**Revised Phase B Site Investigation
Work Plan
Text, Tables, and Figures**

**Tronox LLC Facility
Henderson, Nevada**

Subject: Revised SAP Tables, Figures and Plates for the Phase B Source Area Investigation Work Plans for Areas I, II, III and IV, Tronox LLC Facility, Henderson, Nevada (Facility # H-000539)

Re: **Tronox LLC (TRX)**
NDEP Facility ID #H-000539
Nevada Division of Environmental Protection (NDEP) Response to:
Phase B Source Area Investigation Work Plan, Area I (Northern LOUs), Tronox LLC
Facility, Henderson, Nevada
Dated April 3, 2008

For: Lou 1, Lou 10, Lou 22 & Lou 23
 X = delete
 O = relocate boring
 + O = add well
 (8 changes)

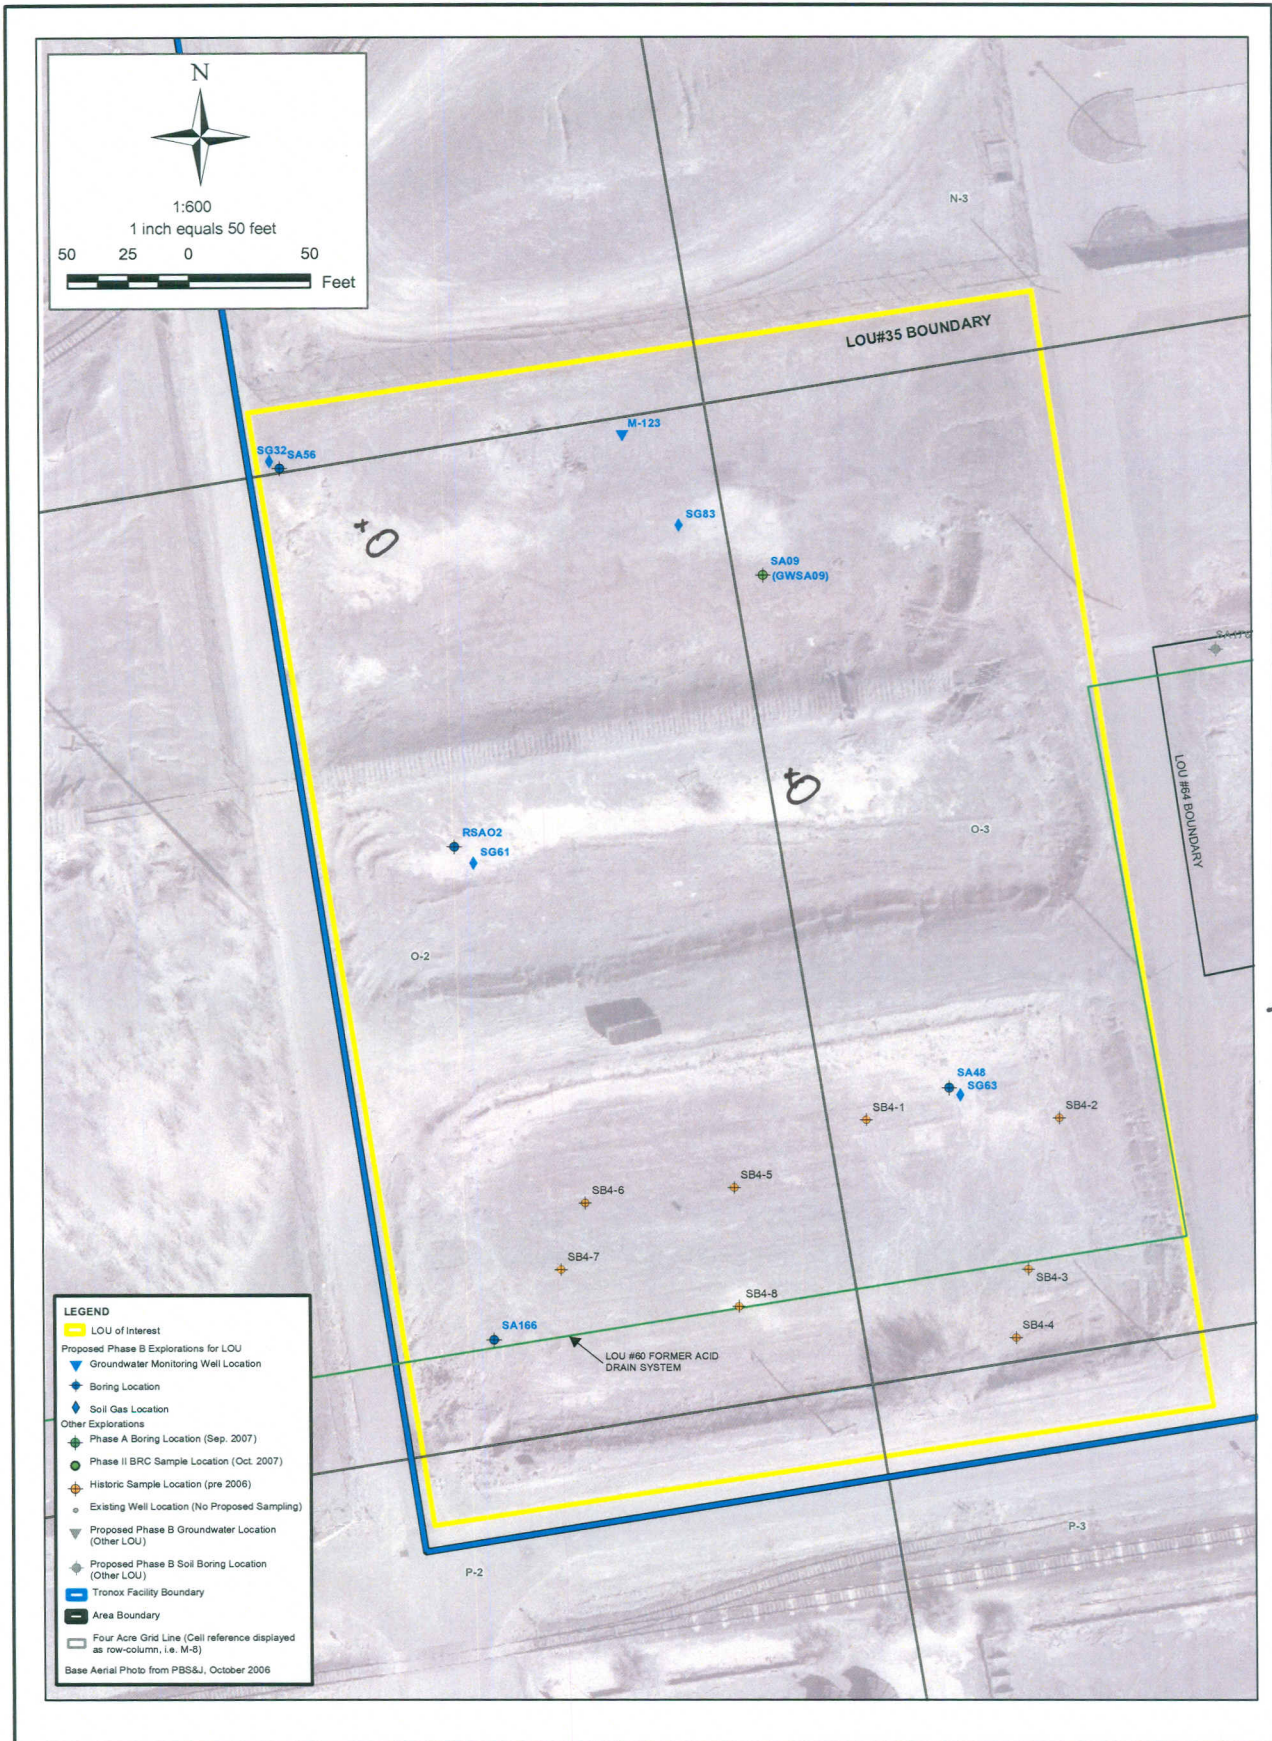
- i. Table A, please see the above comments for Table 2 as applicable.
 - ii. Figure 1, RSAI2 and RSAI3 should be relocated as discussed in the above LOU 1 comments.

- ii. Figure 1, the NDEP has the following comments:
 - 1. SA79 should be relocated as discussed in the above LOU 1 comments.
 - 2. RSAJ8 may be removed from the sampling plan. The NDEP believes that this boring is located too far cross-gradient from LOU 23 for characterization of this LOU.

For: LOU 64 (3 area I changes)
 O = relocate boring to location

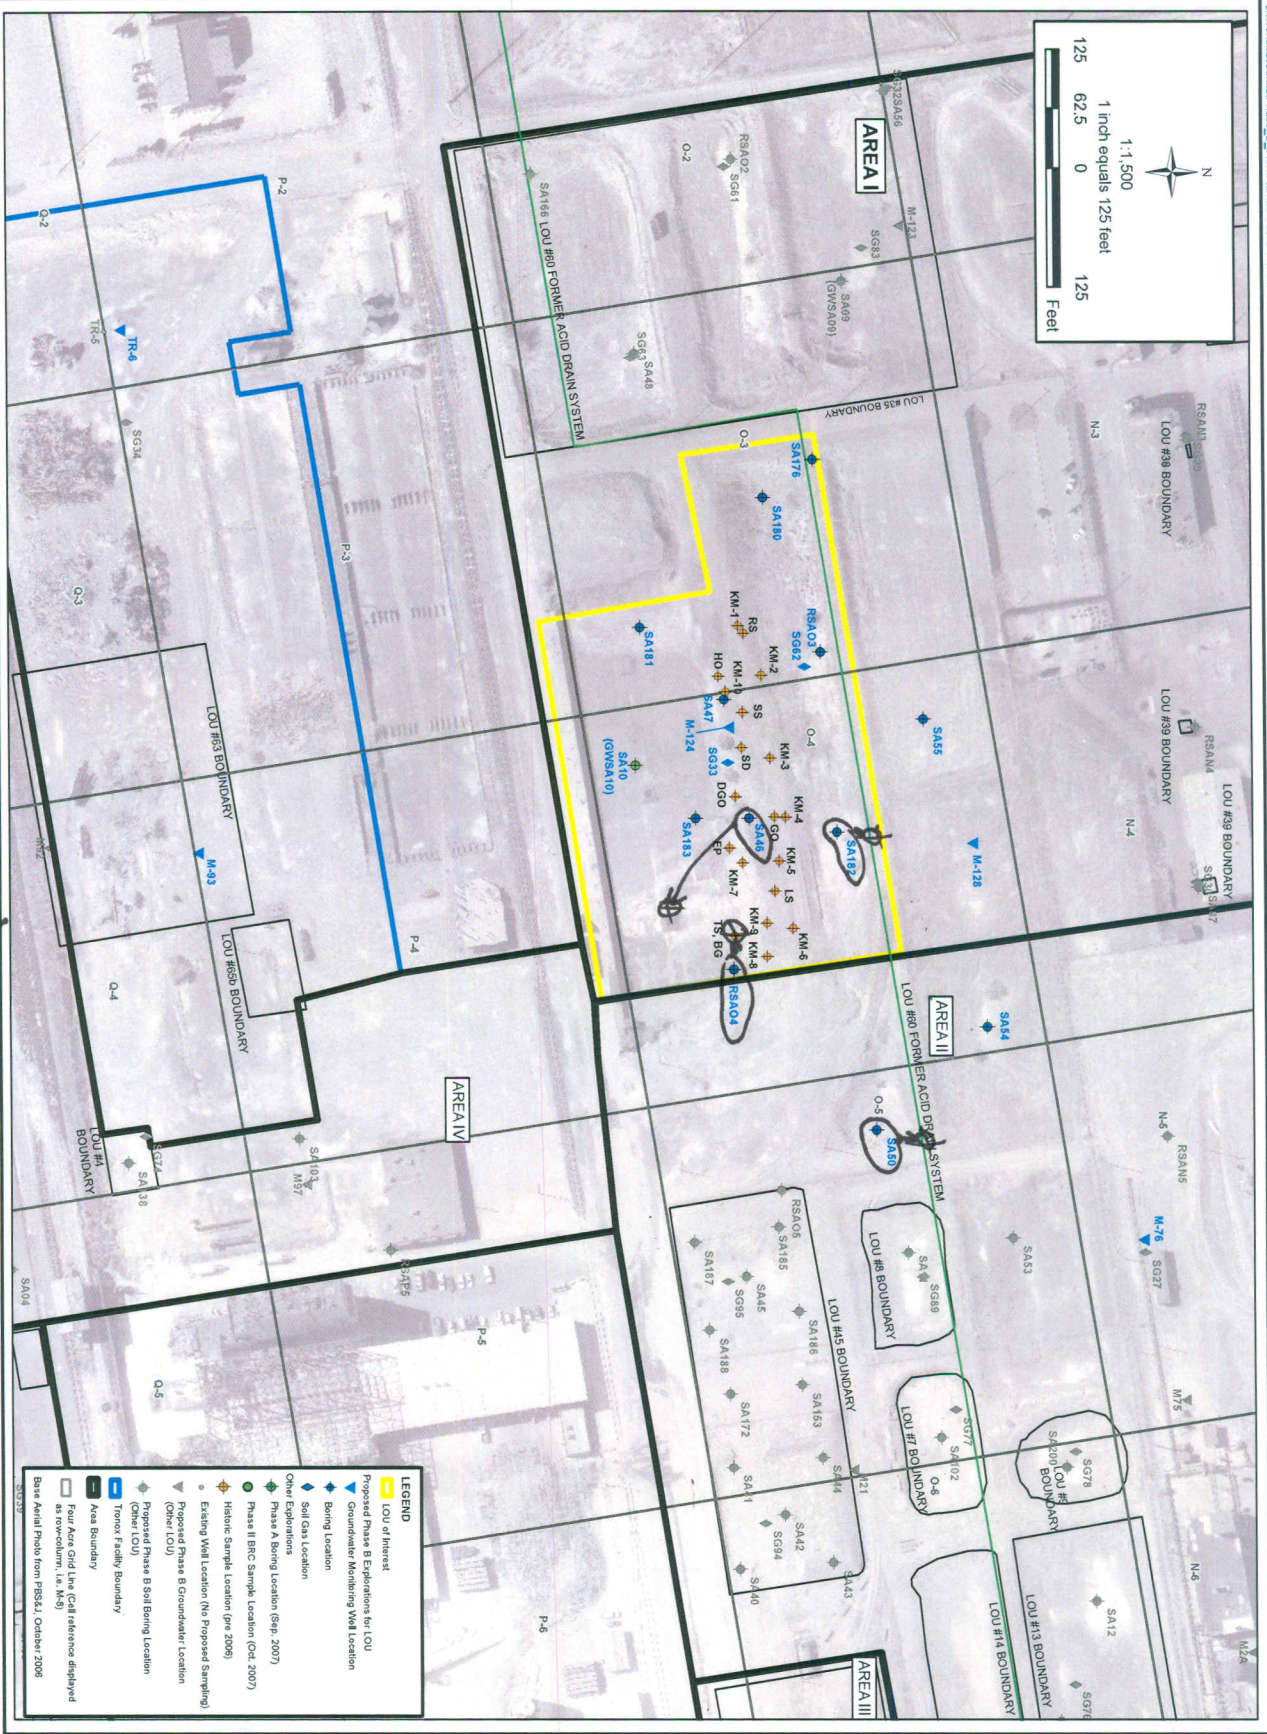
- ii. Figure 1, the NDEP has the following comments:
 1. SA46 should be relocated approximately 75 ft west of the eastern boundary and 90 ft north of the southern boundary of LOU 64.

FIGURE NUMBER:	1
SHEET NUMBER:	X

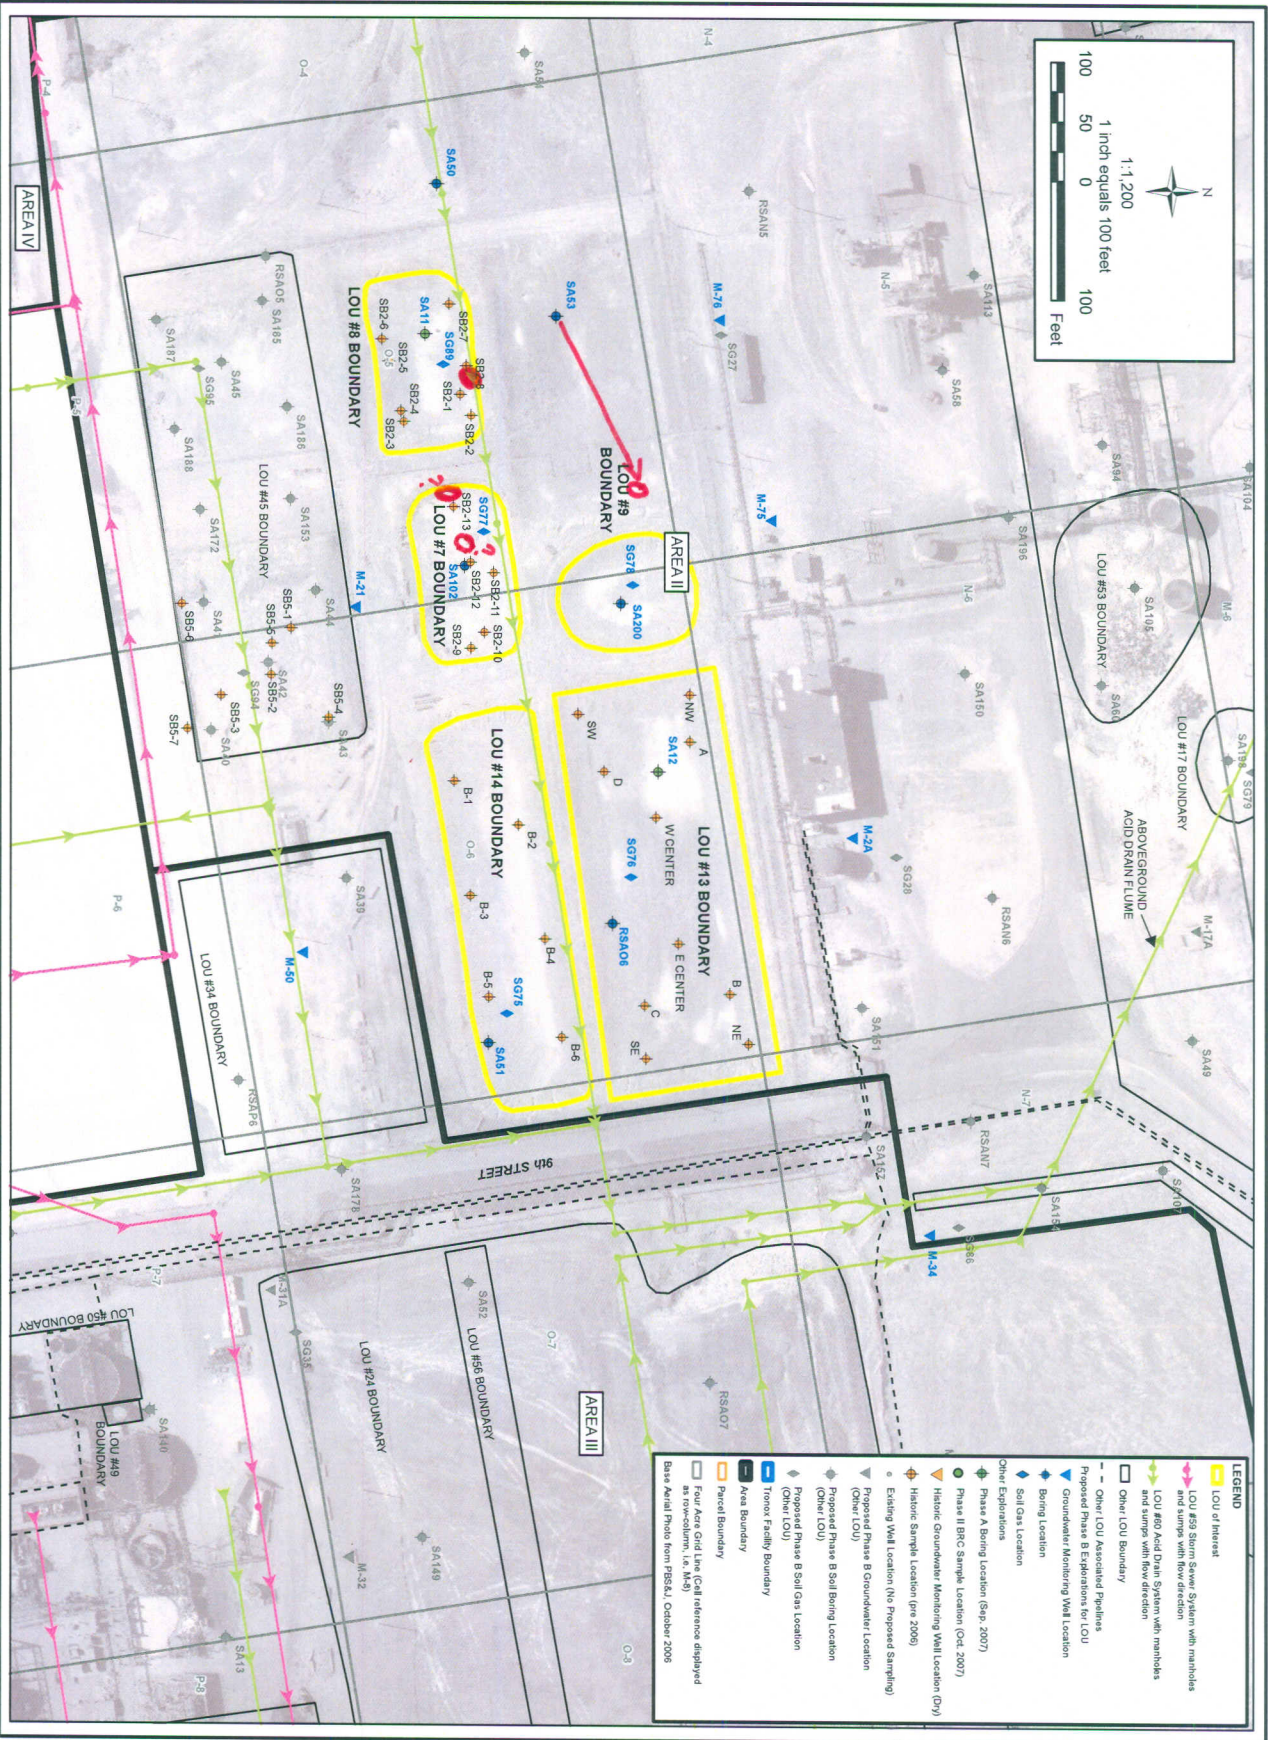
• move SAS3 to white stained soil west of LOU 9
 • additional boring near SB2-8 (LOU 8)
 • additional boring in LOU 7 where spill stains are noted
 • additional boring in LOU 7 where white encrustments are located

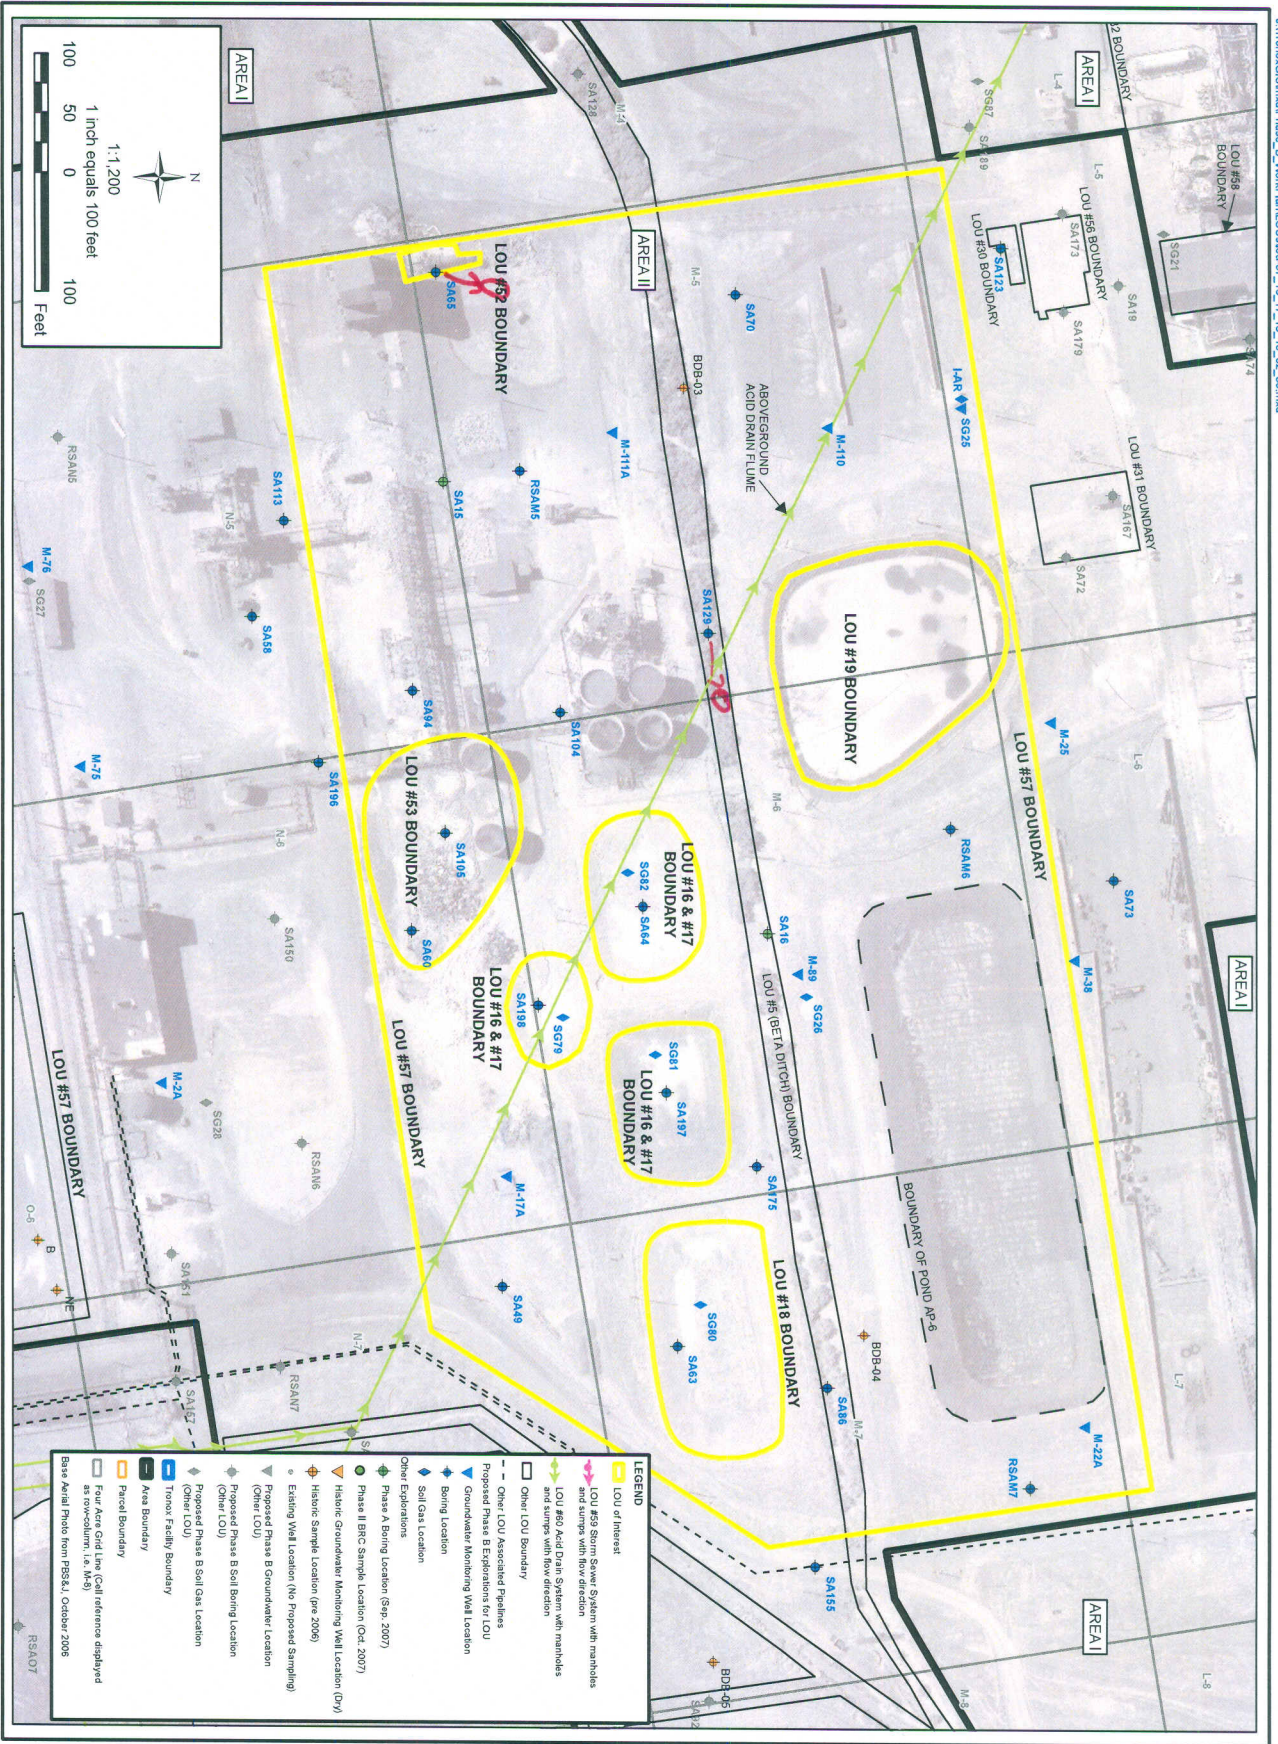
move SA65 to area of depression off of NEC of LOU #52

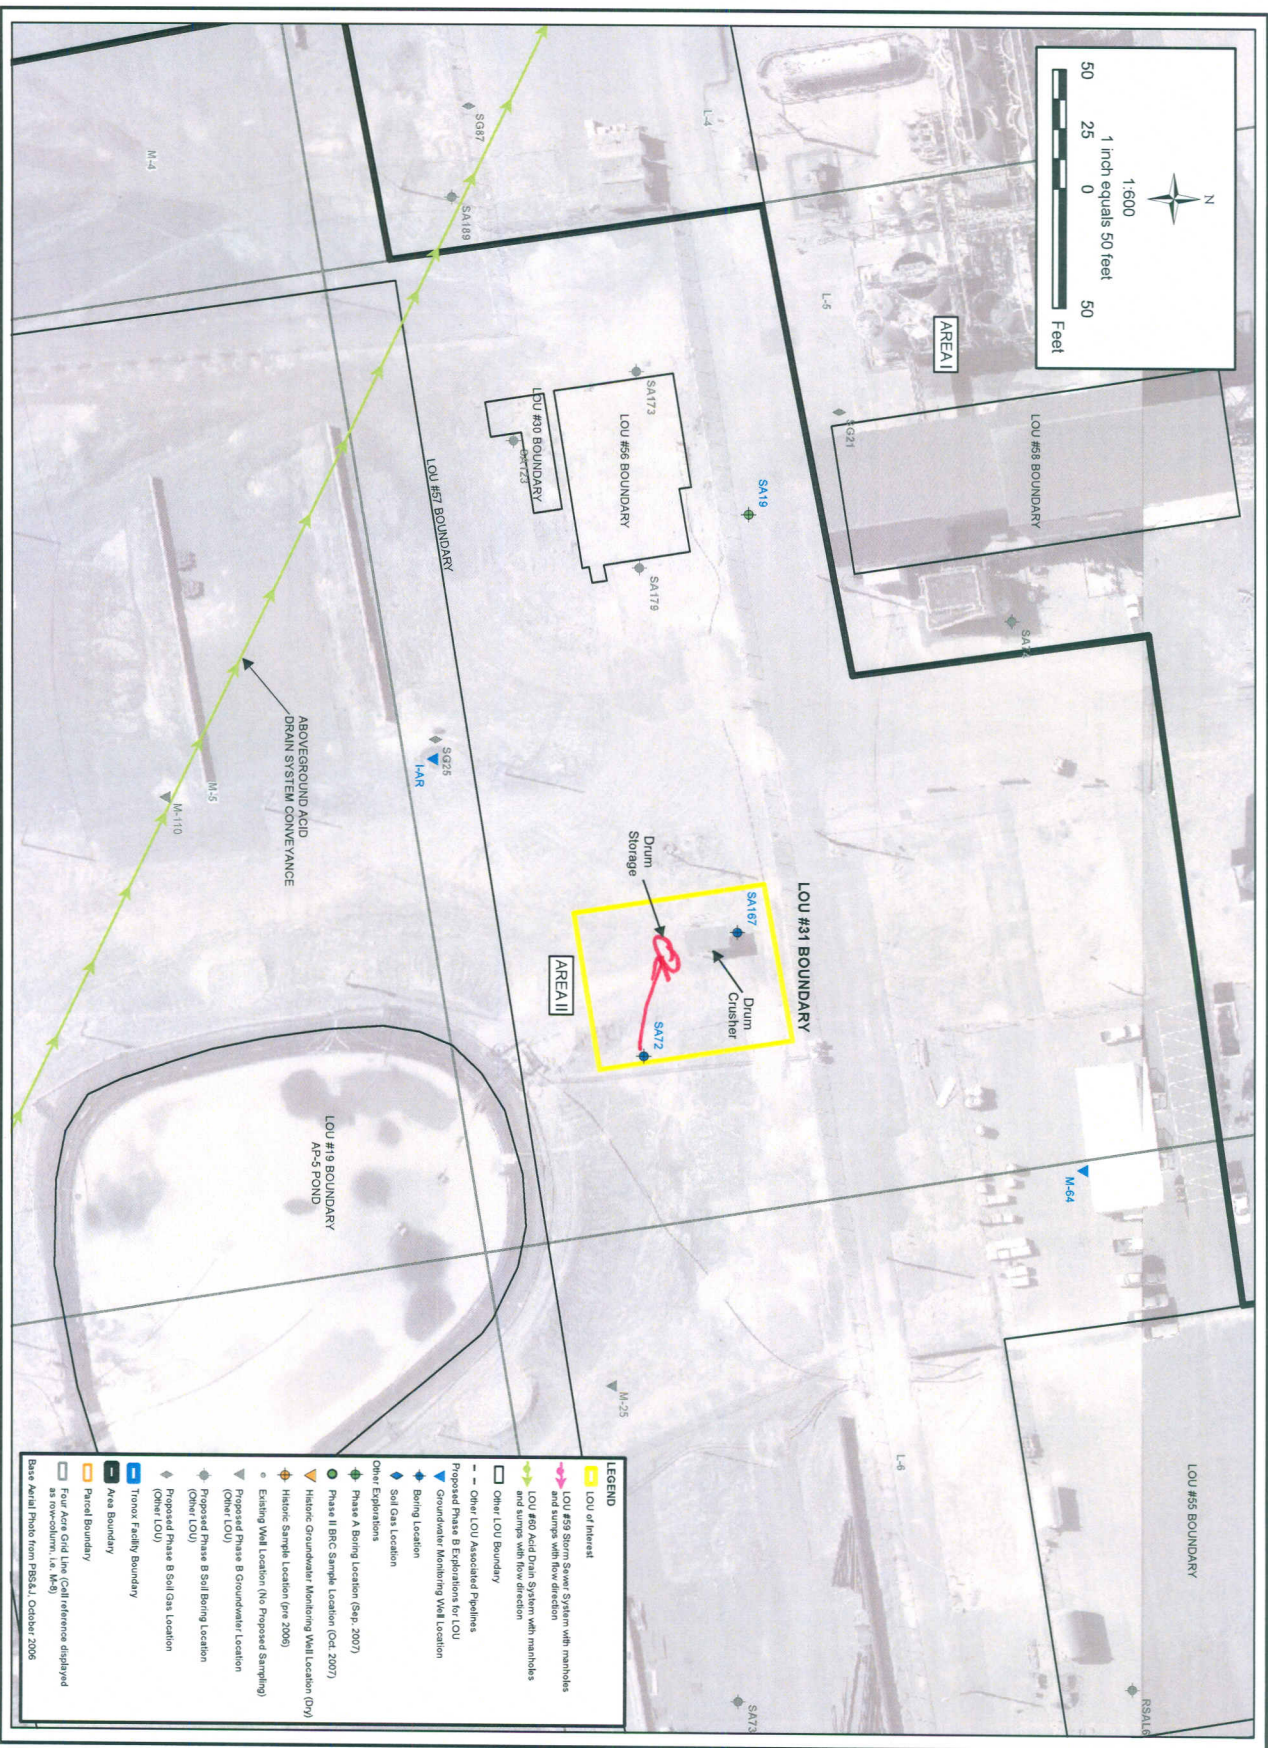
Move SA72 to Drum Storage Area
